Niagara Mohawk

February 7, 2000
NMP2L 1932

RE: Nine Mile Point Unit 2
Docket No. 50-410
NPF-69
TAC No. MA7119

Niagara Mohawk Power Corporation (NMPC) transmitted an Application for Amendment to Nine Mile Point Unit 2 (NMP2) Operating License NPF-69 on October 25, 1999 (NMP2L 1907). The Application for Amendment contained proposed changes to the Technical Specifications (TS) set forth in Appendix A of the above mentioned license to support the activation of the Oscillation Power Range Monitor (OPRM) function. This information supplements that Application for Amendment.

Figure 3.4.1-1 (Page 1 of 1)
Stability Monitoring Power-to-Flow Map

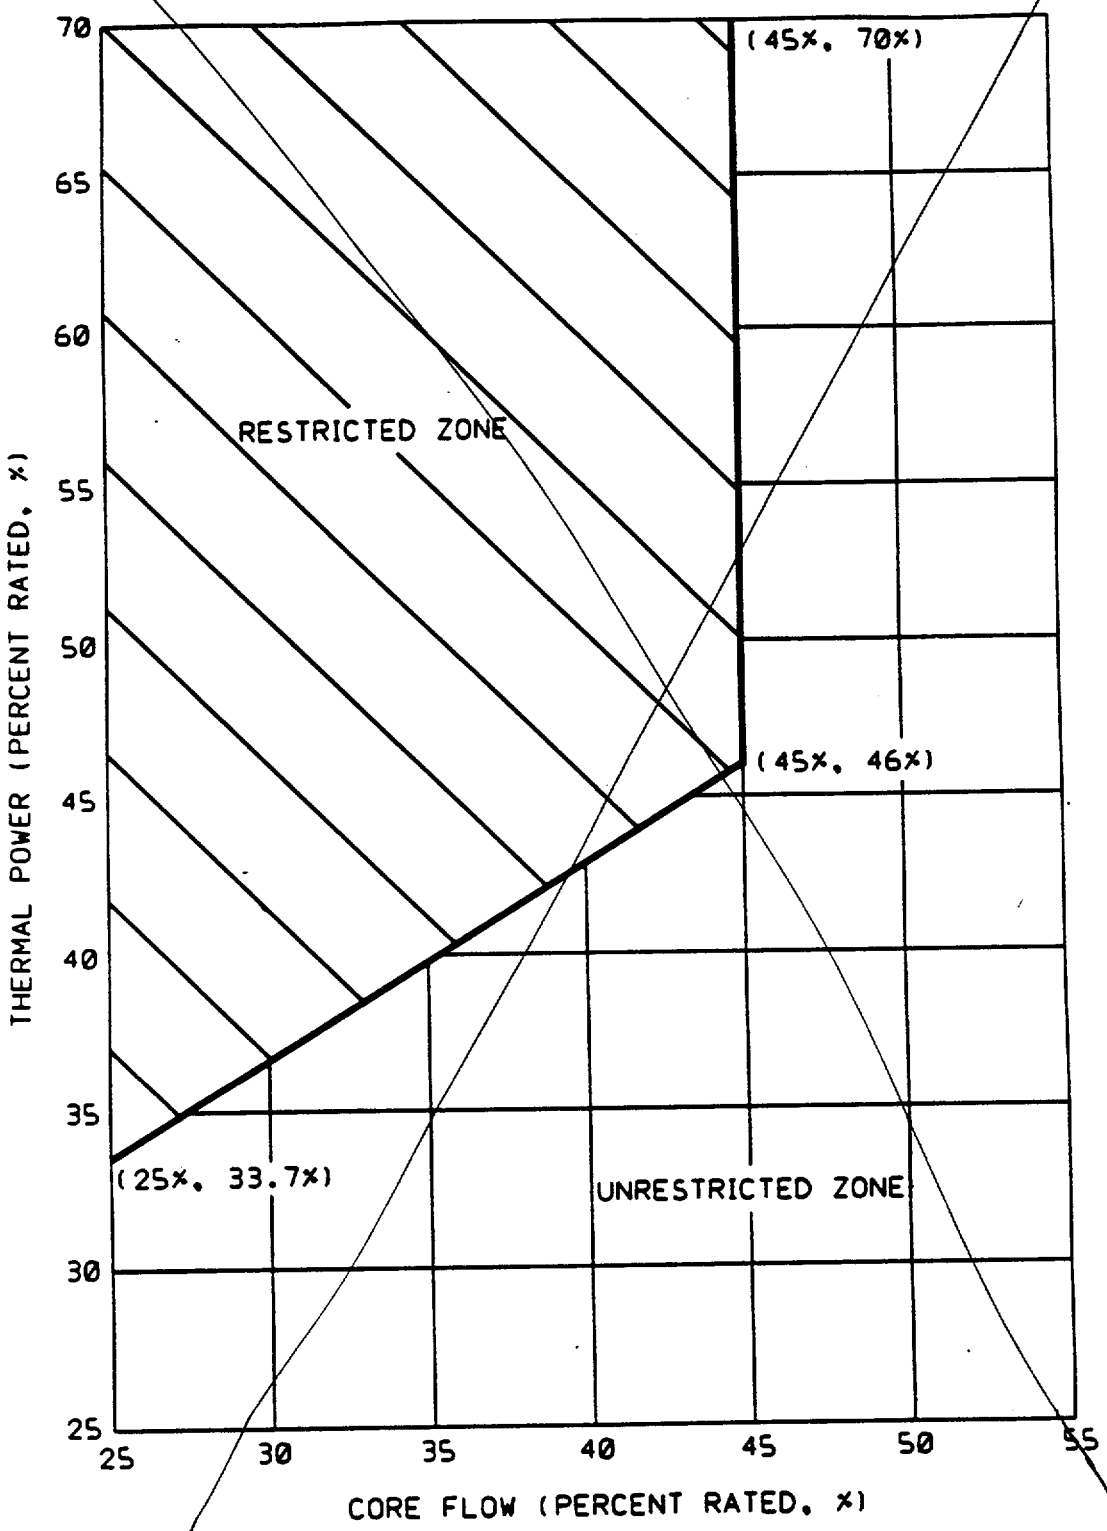
LCO 3.4.1 Two recirculation loops with matched flows shall be in operation ~~in the "Unrestricted Zone" of Figure 3.4.1-1~~,

One recirculation loop shall be in operation ~~in the "Unrestricted Zone" of Figure 3.4.1-1~~ with the following limits applied when the associated LCO is applicable:

~~GE issued Reference 5 to address the stability issue and to establish the stability zones. Subsequently, the zones have been re-established due to power uprate. Figure 3.4.1-1 has been divided into two major zones; the "Unrestricted Zone" and the "Restricted Zone." Continuous operation is permitted in the "Unrestricted Zone" while limited operation is permitted in the "Restricted Zone" due to the potential for thermal-hydraulic oscillations. In addition, the actions to take when operating with one or two recirculation loops in the "Restricted Zone" is based upon core flow being > 39% of total core flow or ≤ 39% of total core flow. The 39% value is equivalent to the minimum core flow for two recirculation pumps operating at high speed with minimum flow control valve position.~~

With no recirculation loops in operation, the ~~probability of~~ unit ~~thermal-hydraulic oscillations is greatly increased. Therefore, action must be taken as soon as practicable to ensure operation is within the "Unrestricted Zone" of Figure 3.4.1-1, assuring the stability concerns are addressed. The 2 hour Completion Time provides a reasonable amount of time to restore operation to the "Unrestricted Zone" of Figure 3.4.1-1. This may be performed by reducing THERMAL POWER by inserting control rods.~~

~~This SR ensures the combination of core flow and THERMAL POWER are within appropriate limits to prevent uncontrolled thermal-hydraulic oscillations. At low recirculation flows and high reactor power, the reactor exhibits increased susceptibility to thermal-hydraulic instability. Figure 3.4.1-1 is based on guidance provided in References 5, 6, and 7. The 12 hour Frequency is based on operating experience and the operator's inherent knowledge of the reactor status, including significant changes in THERMAL POWER and core flow.~~
